ADDRESS: 4045-61 MAIN ST

Proposal: Construct multi-unit residential building

Review Requested: Final Approval

To: Andrew Zakroff, Urban Conversions
From: AKRF, Inc.
Date: June 12, 2024
Re: 4045-61 Main Street, Philadelphia, PA
Flood Resiliency Design Review

Figure 3: First floor building access points (per CBP Architect 6/06/24 plans)

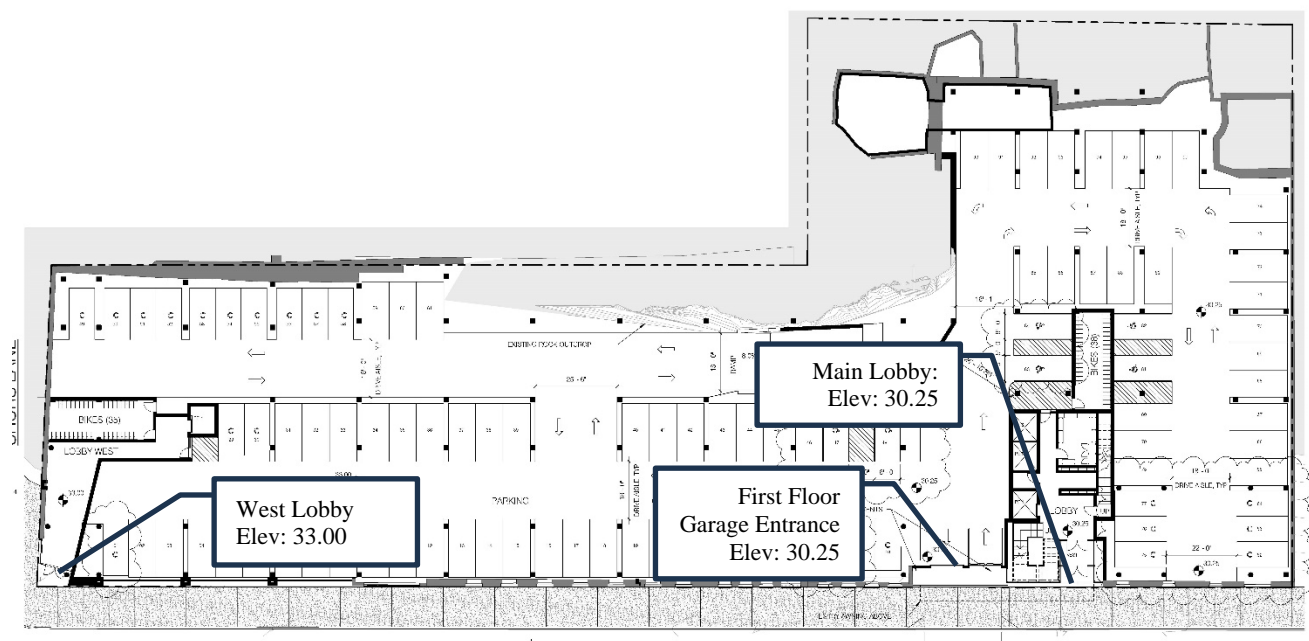
Two pedestrian entrances and one vehicular entrance are located along Main Street and access the first floor of the building. The slope along the building's frontage results in a higher elevation for the west lobby (Elev 33.00) than the main lobby (Elev. 30.25). The vehicular entrance provides entrance and exit from the first-floor garage onto Main Street. In dry conditions, these will be the primary access points. In smaller flood events, the west lobby may remain operational while the main lobby is inundated.

Residents entering the building from the first level can access the building's second floor via elevator and staircase located in the main lobby, the elevator in the west lobby, or the vehicular ramp to the second-floor parking garage.

Figure 4: Second floor building access points (per CBP Architect 6/06/24 plans)

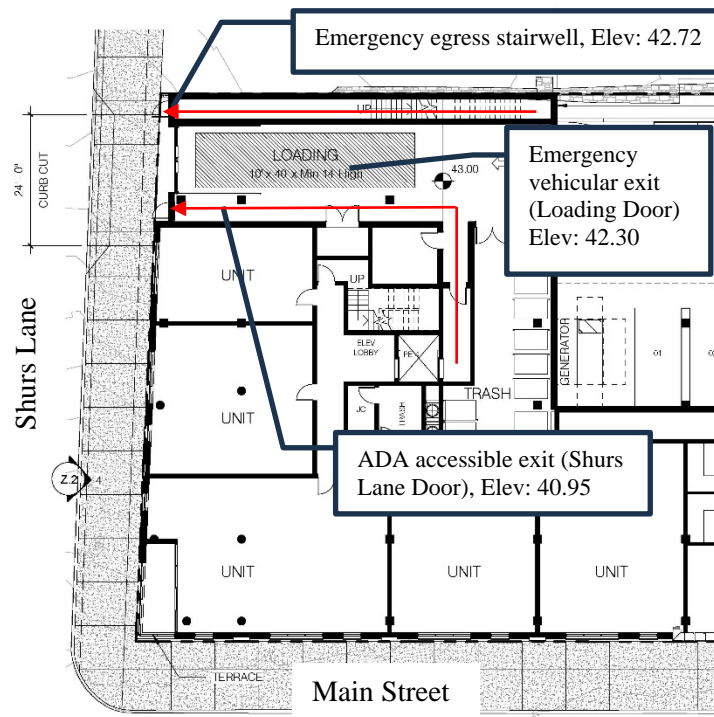
Emergency egress routes from the building connect residential spaces to Shurs Lane. Shurs Lane abuts the northern face of the building and has an elevation of 42.80 at the building's northeastern corner. Residents exiting from the third floor or higher may use the stairwell which meets Shurs Lane at 42.72. Second floor residents can exit the building via a second access point along Shurs Lane at 40.95. This route is an Americans with Disabilities Act (ADA) accessible route and may also be used by residents exiting the second-floor elevators.

The second-floor vehicular access is dedicated to loading during dry conditions. However, in the event of a flood, this loading entrance will become the designated vehicular emergency exit, meeting Shurs Lane at 42.30.

The plan for emergency egress provides exit routes at the highest feasible elevations. The emergency stairwell will include a vent and flood damage resistant materials to reduce hydrostatic pressure and reduce damages in an extreme flood event, meeting ASCE 24-14 standards for building access below the DFE. Residents using the emergency exit can travel directly uphill on Shurs Lane to higher ground.

Figure 8: Approximate historic flood event elevations compared to the proposed residential building elevations.

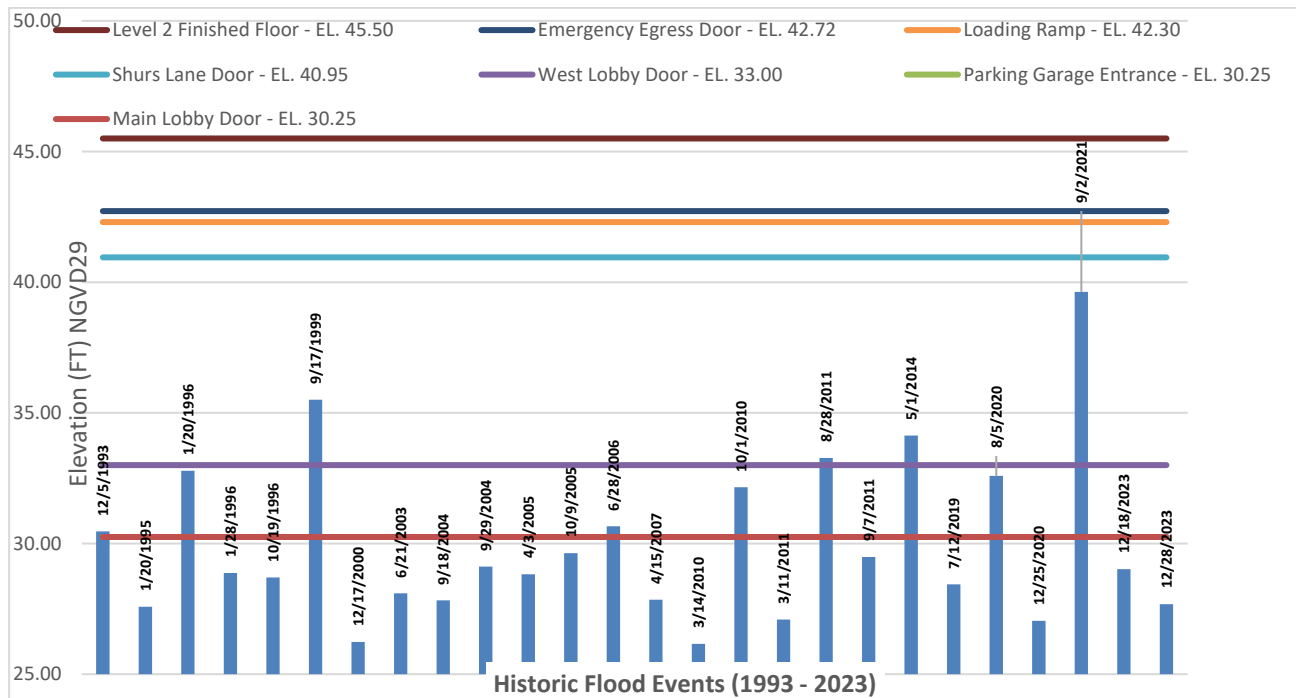
The linear fit line was then used to estimate Site flooding elevations for the significant flood events identified between 1993 and 2023. Hurricane Ida (2021) was the highest flood event on record in this period, with an on-site flood elevation of 39.63 feet NGVD29. Hurricane Floyd (1999) was the second highest, with an on-site flood elevation of 35.50 feet NGVD29. All recorded historic flood events are below the DFE for the Site. These historic flood elevations were compared to proposed elevations for building access and finished floors (See Figure 8).

The frequency of flood events exceeding the proposed building elevations was analyzed in Table 2. The number of years in which historic flood events over the period of analysis (1993 – 2023) would have exceeded a building elevation was used to determine the probability of annual exceedance. The Annual Chance of Exceedance indicates the probability that a building location will be flooded in any given year. The maximum flood depth above the elevation was also determined using the largest recorded event (Hurricane Ida).

Based on the historic period of analysis, there is a 30% chance that the parking garage and main lobby inner door may flood in a given year. If this occurs, residents may exit through the West Lobby, Shurs Lane door, or emergency egress door. The Shurs Lane door (ADA-accessible emergency egress), loading ramp (emergency vehicular egress), and emergency egress stairwell would not have been impacted by flood events experienced in the past 30 years. The lowest residential units would also have remained dry.
